ATTACHMENT TO LICENSE AMENDMENT NOS. 16 AND 10

Replace the following pages of the Appendix A portion of the Technical Specifications with the attached revised pages bearing the same numbers except as otherwise noted. Changed areas on these pages are shown by marginal lines:

SUPPORTING AMENDMENT NOS. 16 AND 10 TO FACILITY  
LICENSE NOS. DPR-42 AND DPR-60

PRAIRIE ISLAND NUCLEAR GENERATING PLANT UNIT NOS. 1 AND 2

FIGURE TS.3.10-6

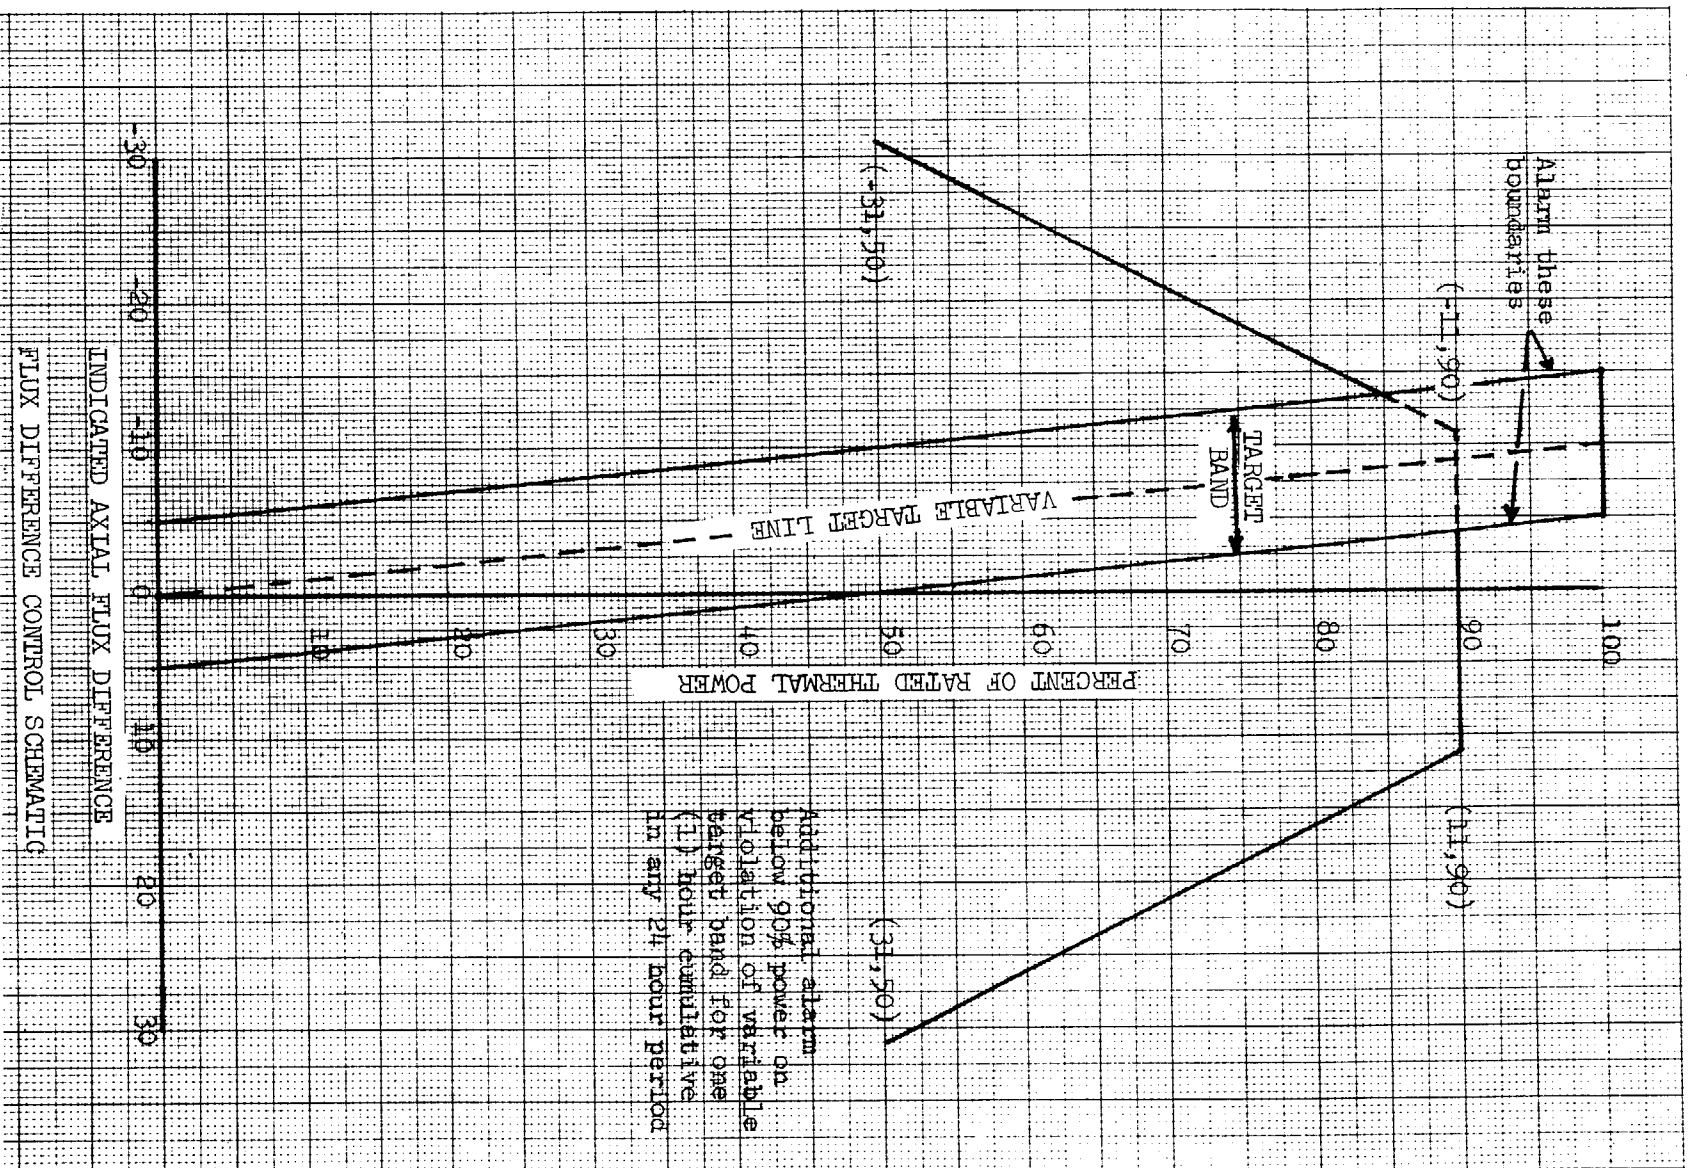
TS 3.10-1  
TS 3.10-2  
TS 3.10-3  
TS 3.10-4  
TS 3.10-7  
TS 3.10-8  
TS 3.10-9  
TS 3.10-10  
TS 3.10-10a (new page)  
TS 3.10-11 (correction of misspelled word only in first line)  
TS 3.10-5  
TS 3.10-6 (new figure)  
TS 3.10-7 (new figure)

6. At a power level no greater than 90 percent of rated power,
  - a. The indicated axial flux difference may deviate from its  $\pm 5\%$  target band for a maximum of one\* hour (cumulative) in any 24 hour period provided the flux difference does not exceed an envelope bounded by -11 percent and +11 percent at 90% power and increasing by -1 percent and +1 percent for each 2 percent of rated power below 90% power as shown by Figure TS.3.10-6.

FIGURE TS.3.10-7

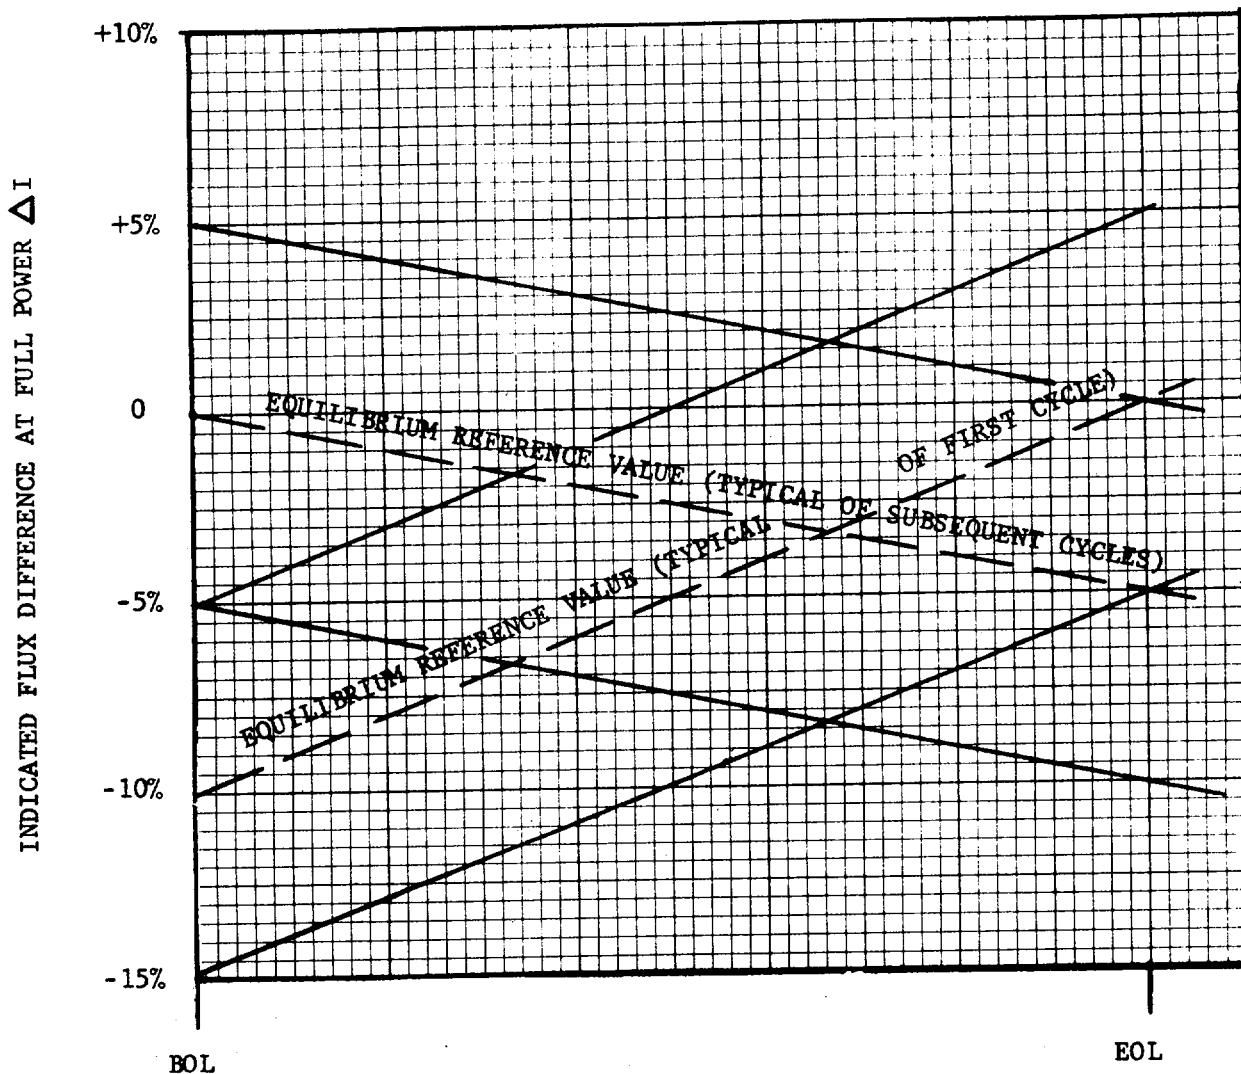
Condition for Operation. Only when the target band is violated do the limits under Specification TS.3.10.B.6.a apply. Figure TS.3.10-2 shows a typical monthly target band near beginning of life and the appropriate boundaries and alarms if the target band is exceeded.
